## ArevaEPRDCPEm Resource

Attached is a DRAFT response for Question 07.01-35 of RAI No. 505 (FSAR Ch. 7) provided in the attached file in advance of the May 30, 2012 final date.

All indicated changes are in response to RAI 505, 07.01-35

Figure 7.6-7—SCWS Train 3 to Train 4 Switchover on Train 3 Low Evaporator Flow / Chiller Blackbox Internal Fault / Loss of UHS-CCWS / SCWS Chiller Evaporator Water Flow Control / LOOP Re-Start Failure Interlock

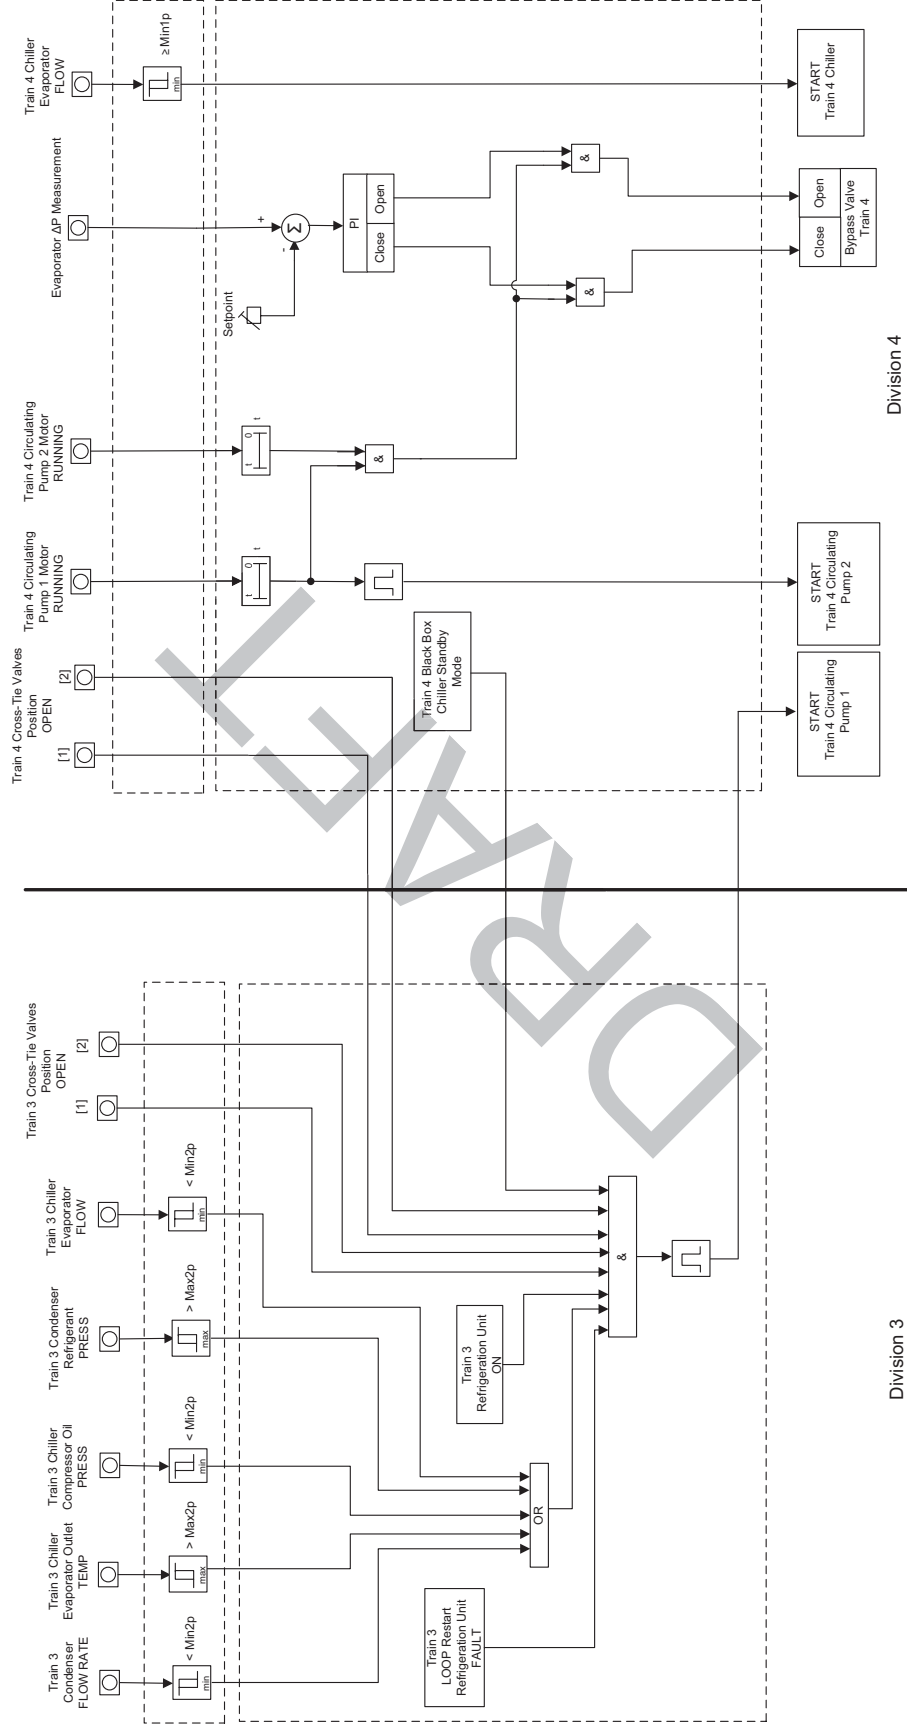
All indicated changes are in response to RAI 505, 07.01-35

Figure 7.6-8—SCWS Train 4 to Train 3 Switchover on Train 4 Low Evaporator Flow / Chiller Blackbox Internal Fault / SCWS Chiller Evaporator Water Flow Control / LOOP Re-Start Failure Interlock

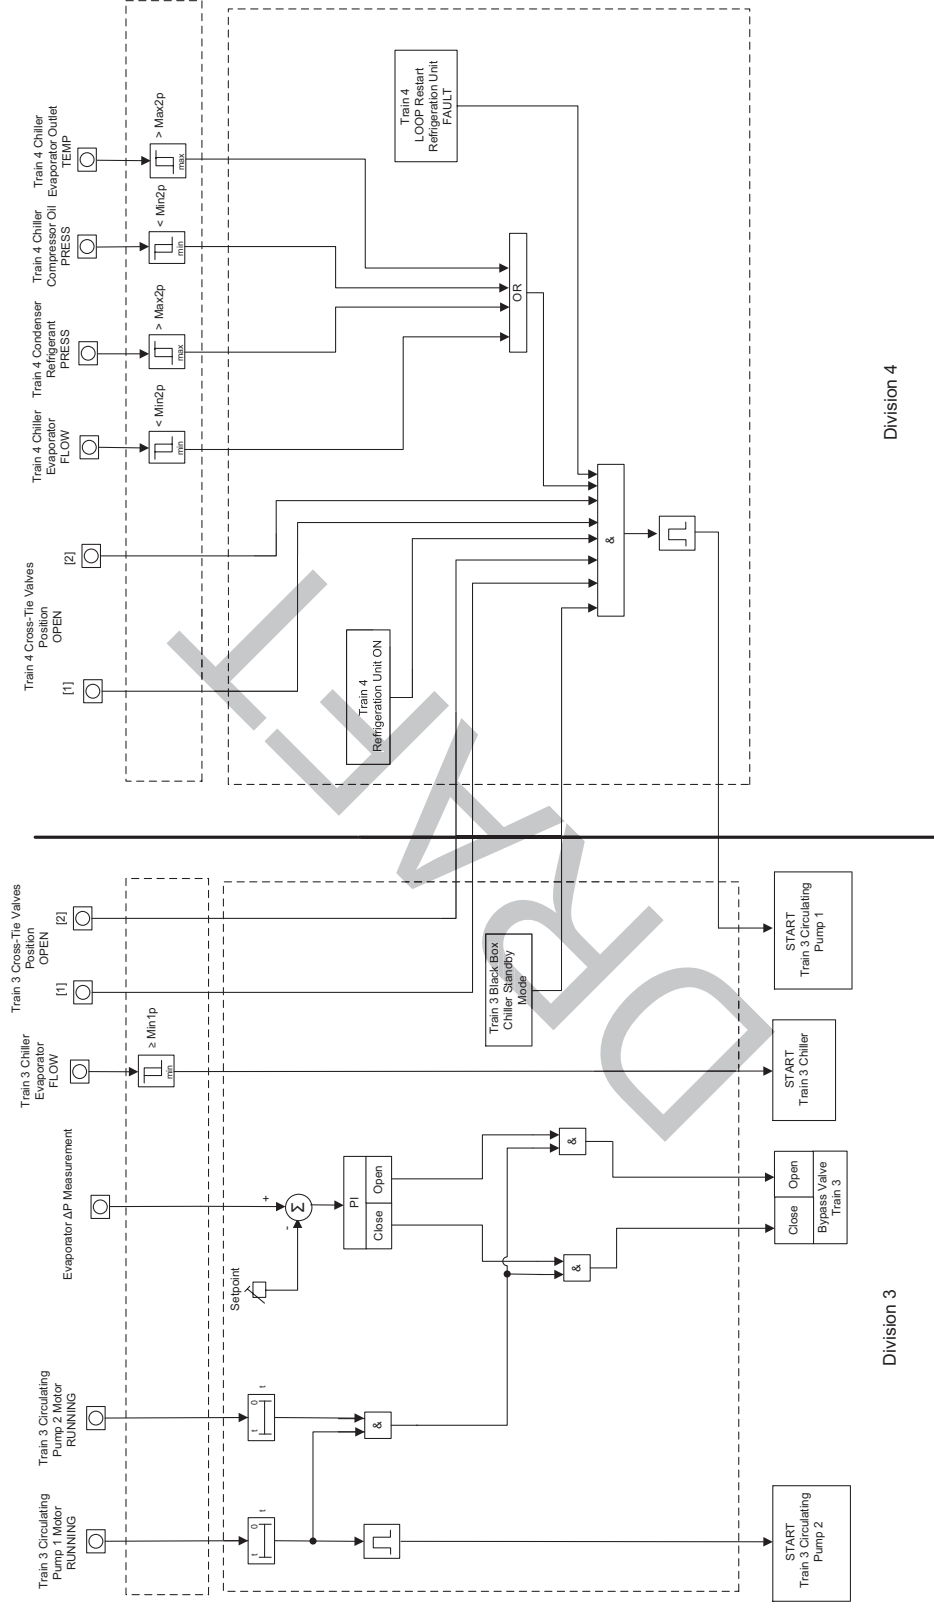
All indicated changes are in response to RAI 505, 07.01-35

Figure 7.6-10—SIS / RHRS Automatic Trip of LHSI Pump (in RHR Mode) on Low-Low RCS Loop Level Interlock

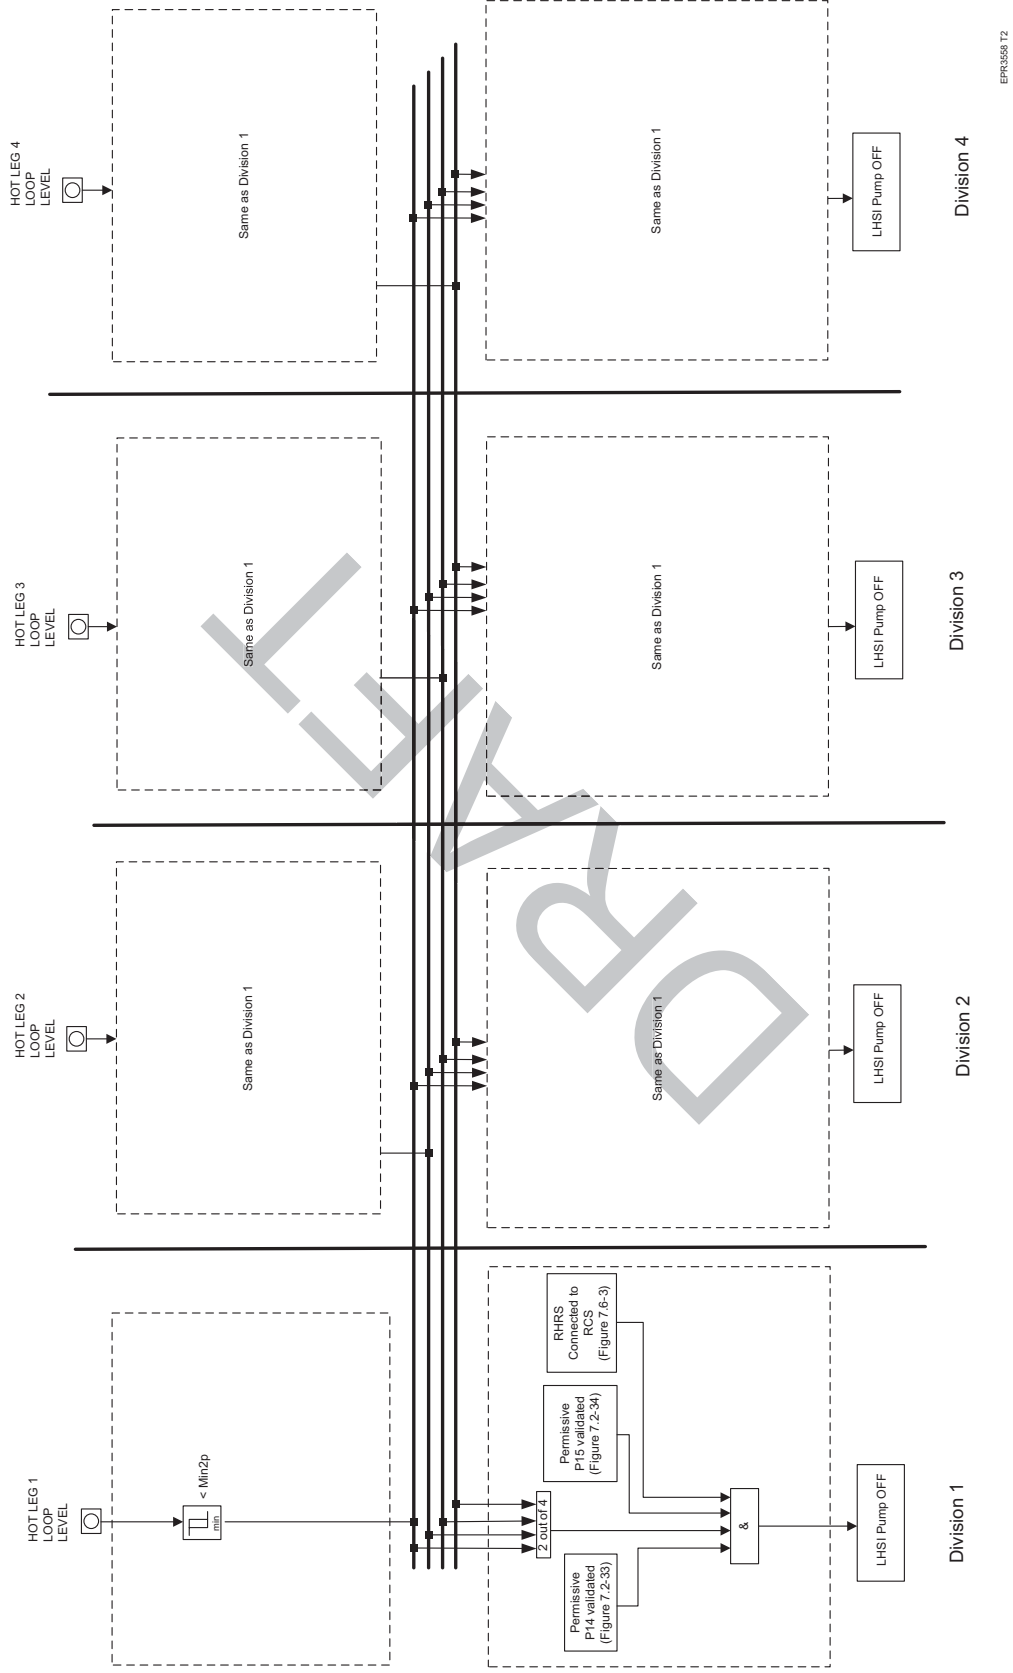
All indicated changes are in response to RAI 505, 07.01-35

Figure 9.4.9-1—Emergency Power Generating Building Ventilation System

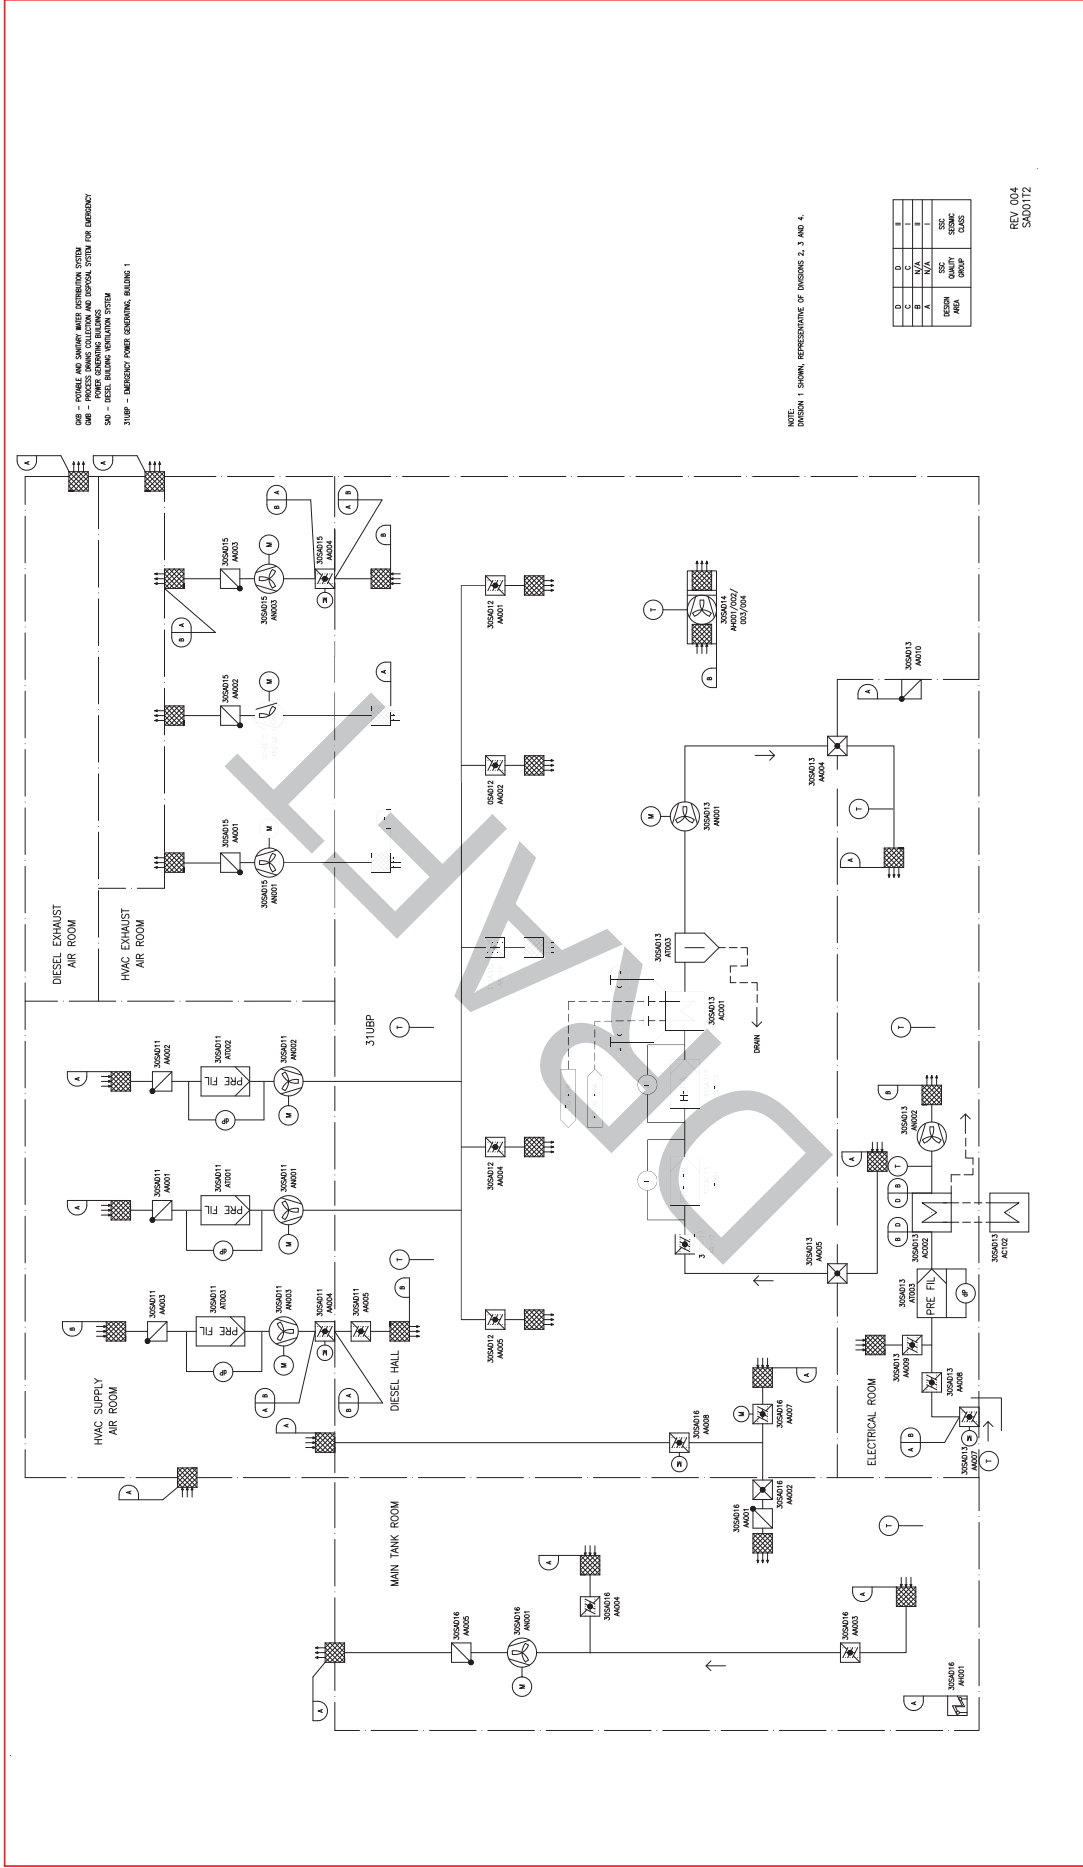
All indicated changes are in response to RAI 505, 07.01-35
